ORIGINATION FORM

Proposed Revisions to a Standard Plans Index

Index Number: 649-031

Index Title: MAST ARM ASSEMBLIES

ELEVATION AND NOTES

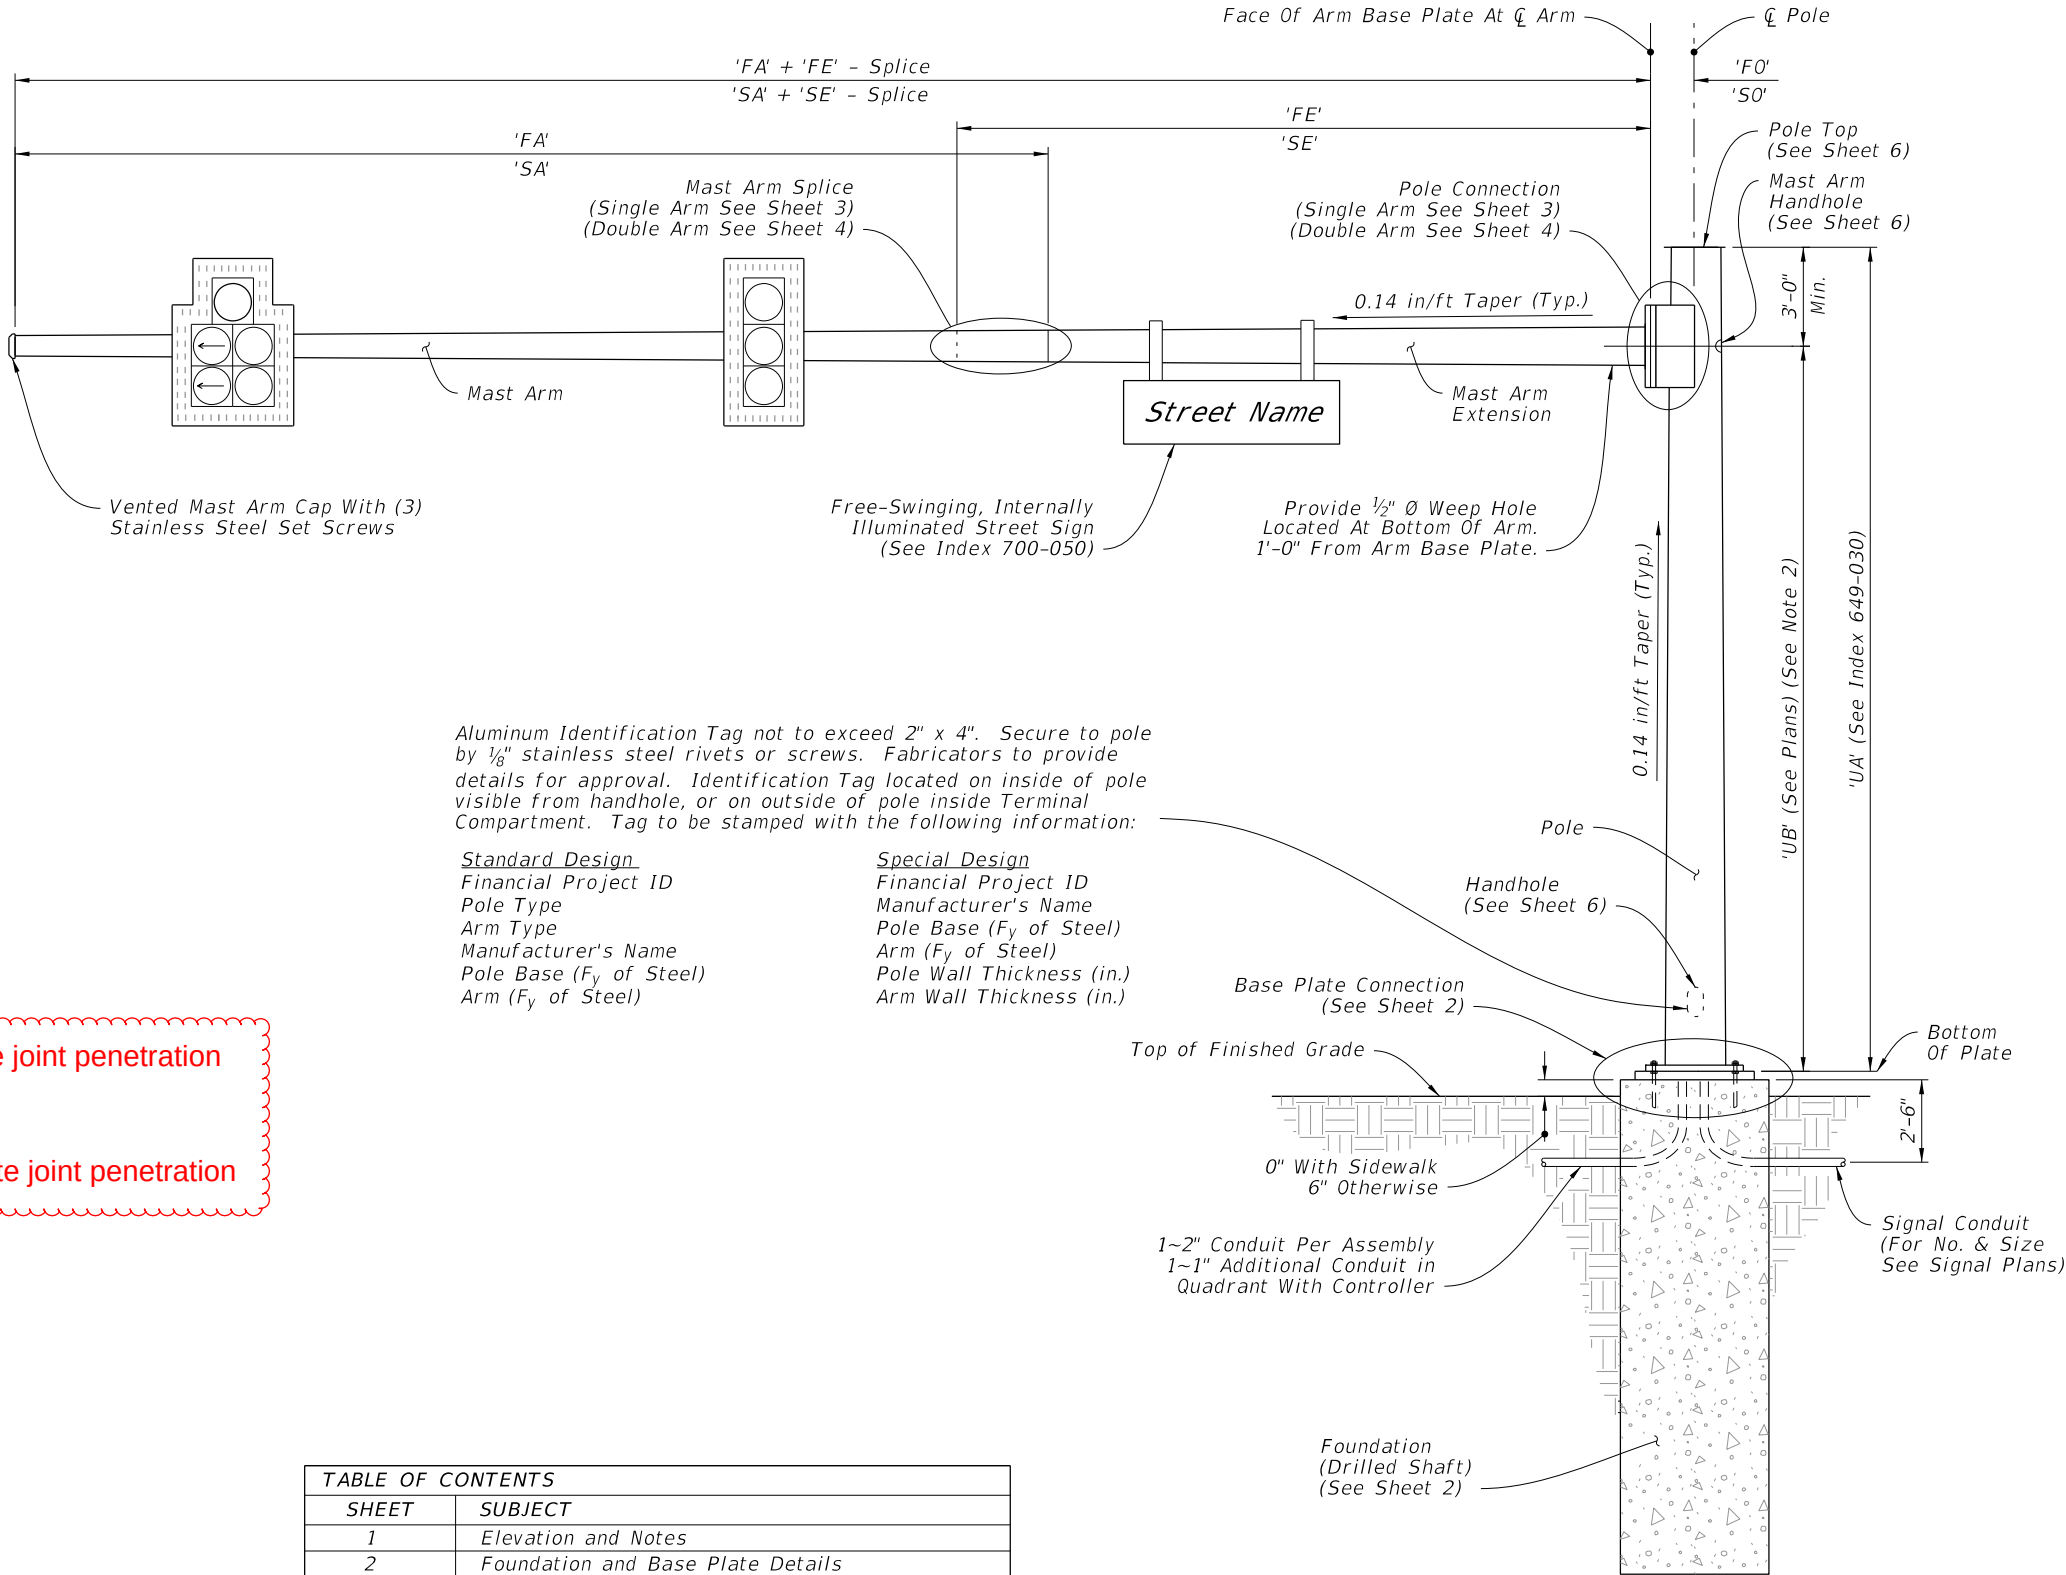
Sheet 1: Changed phrase from "full-penetration groove" to "complete joint penetration."

Sheet 1: Changing non-standard language to standard language consistent with AWS.

1. Use a complete joint penetration weld within 6 inches of the circumferential tube-to-plate connection.
 2. Use complete joint penetration welds on the female end section of telescopic (i.e., slip type) field splices for a minimum length of one and one-half times the inside diameter of the female section plus 6 inches.

DOUBLE ARM CONNECTIONS & SPLICE DETAILS

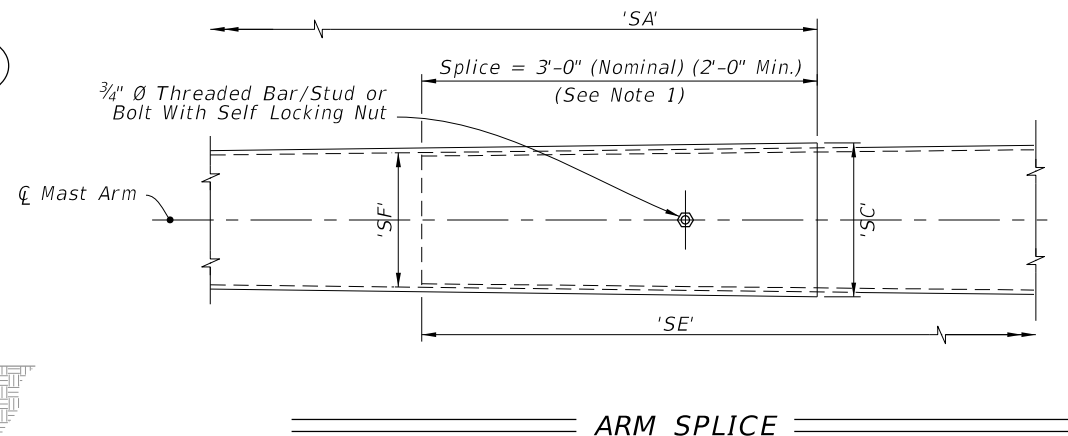
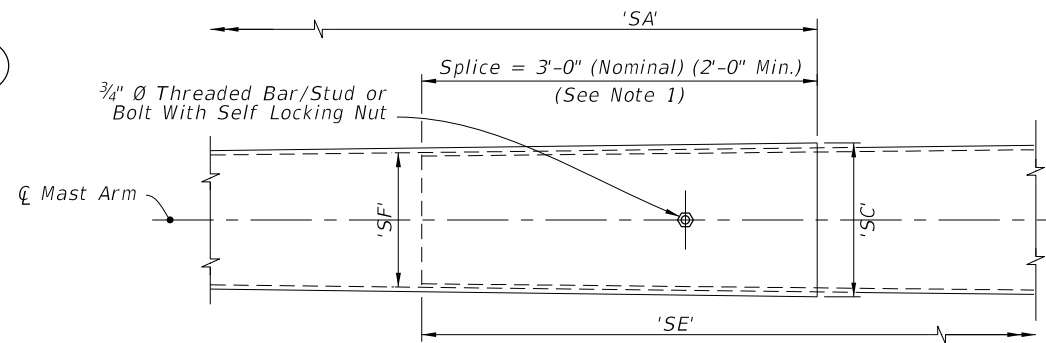
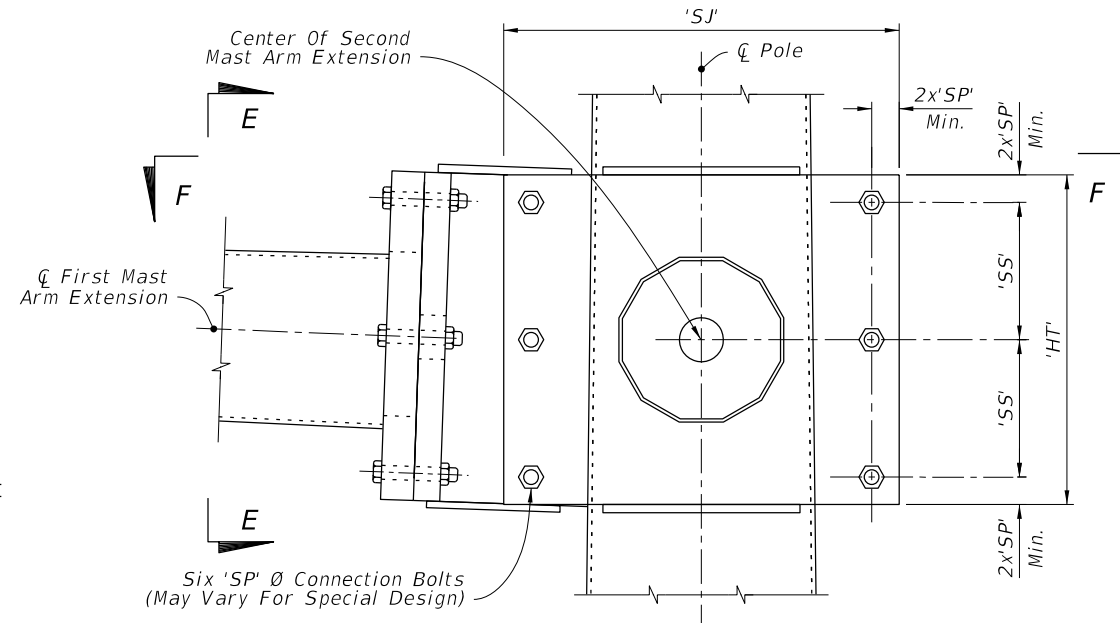
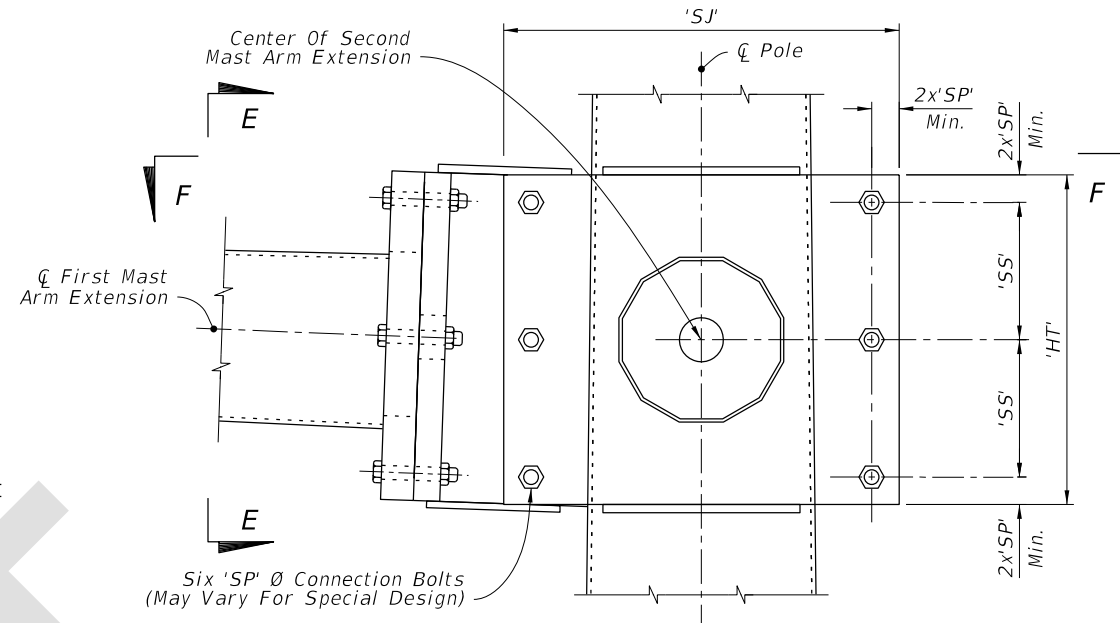
Sheet 4: Changed weld detail to say "CJP."

Sheet 4: Changing non-standard language to standard language consistent with AWS.

HANDHOLE AND POLE TOP DETAILS

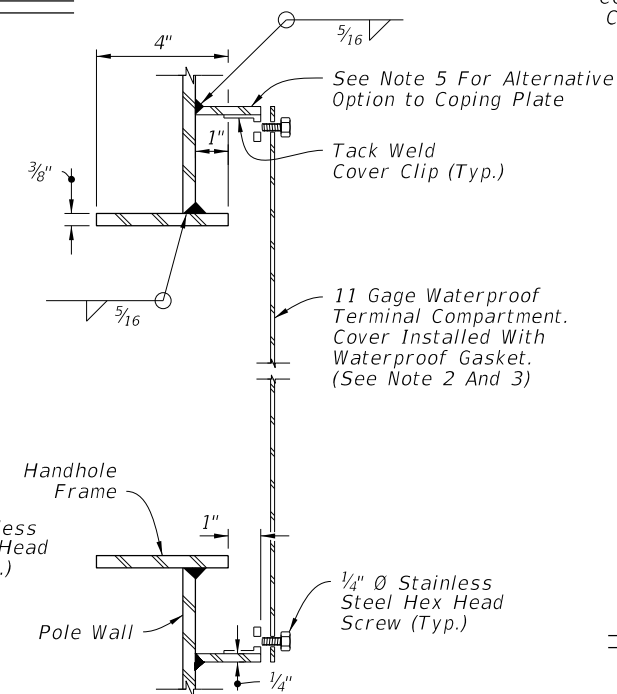
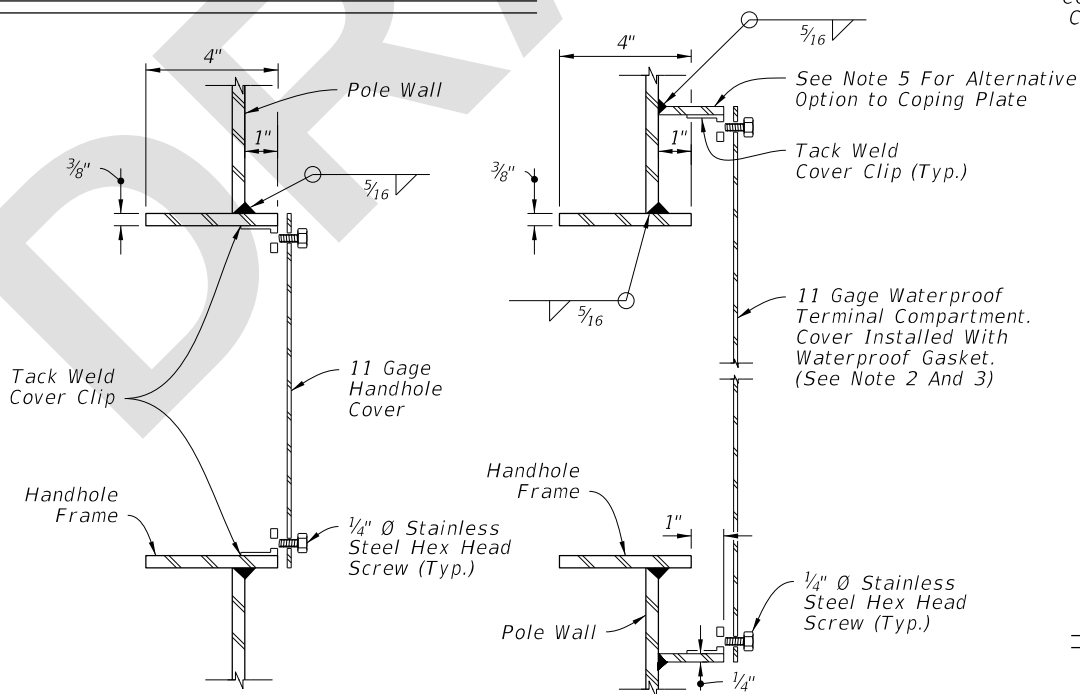
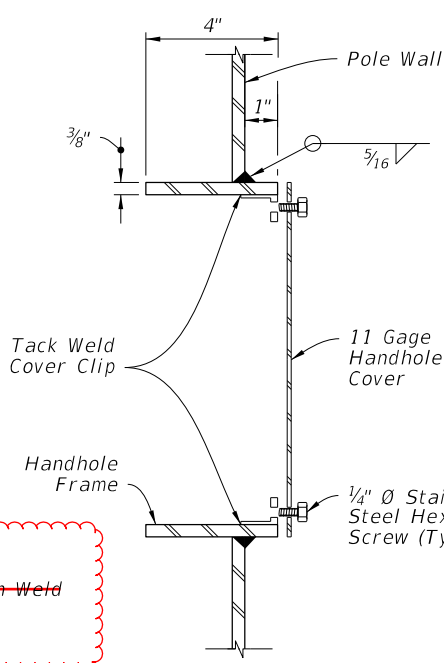
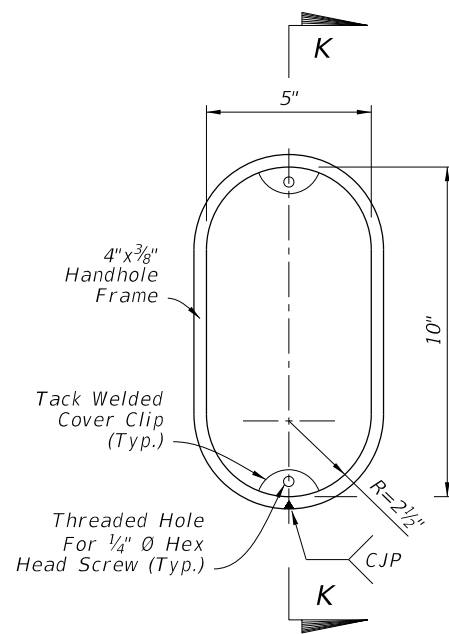
Sheet 6: Changed weld detail to say "CJP."

Sheet 6: Changing non-standard language to standard language consistent with AWS.

SINGLE ARM CONNECTIONS & SPLICE DETAILS

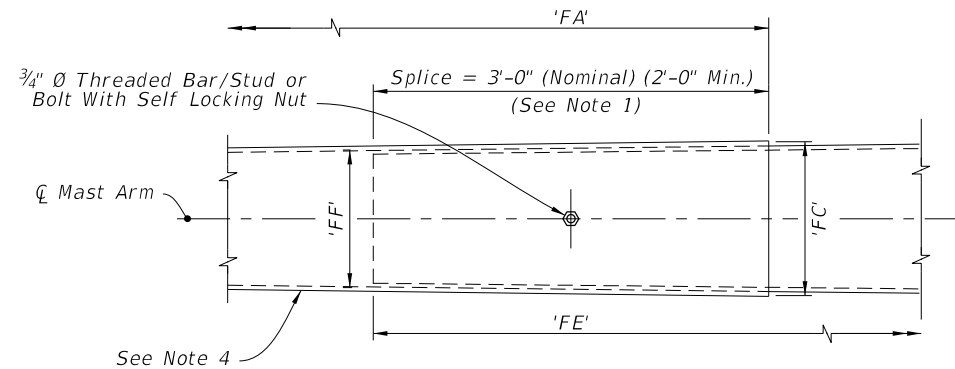
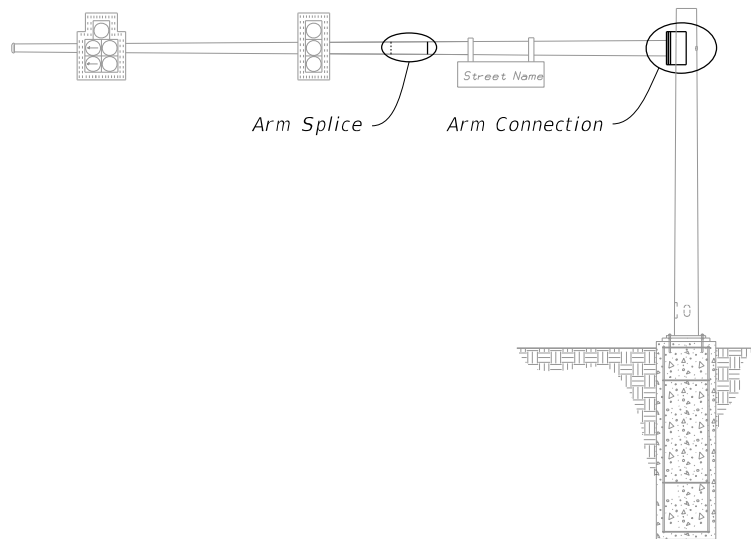
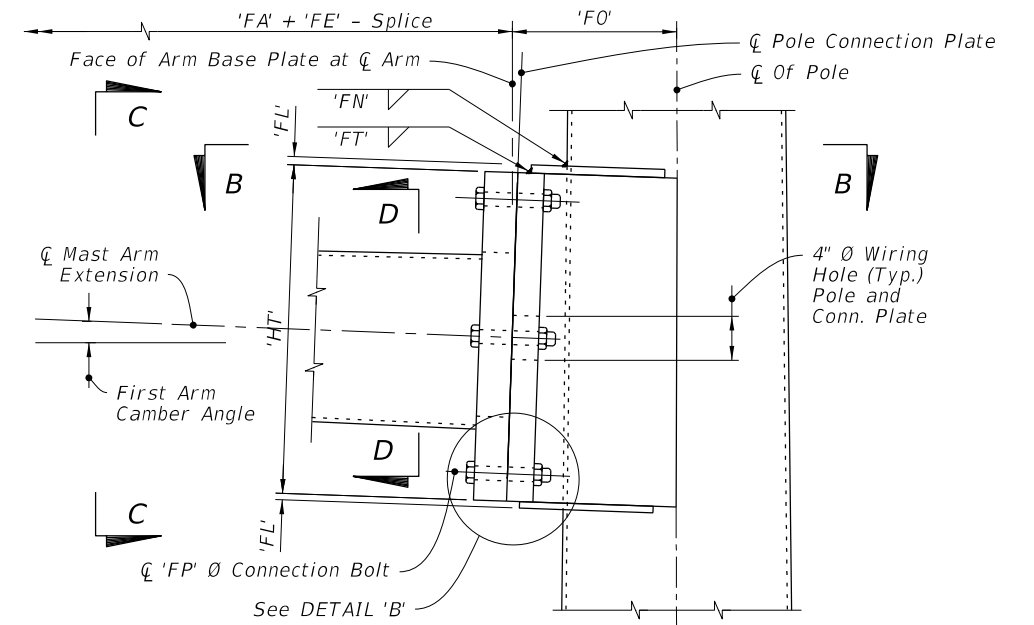
Sheet 3: Added a note about the diameter of the female splice.

Sheet 3: Fabricators were having a problem getting the required splice length due the the diameters of the splice sections. We added some tolerance so that they could more easy attain the required splice length.

4. On the outer mast arm section, the manufacturer may increase both the tip diameter and the base diameter of the female section of the splice by up to 1/8" to meet the required 3'-0" minimum lap splice.
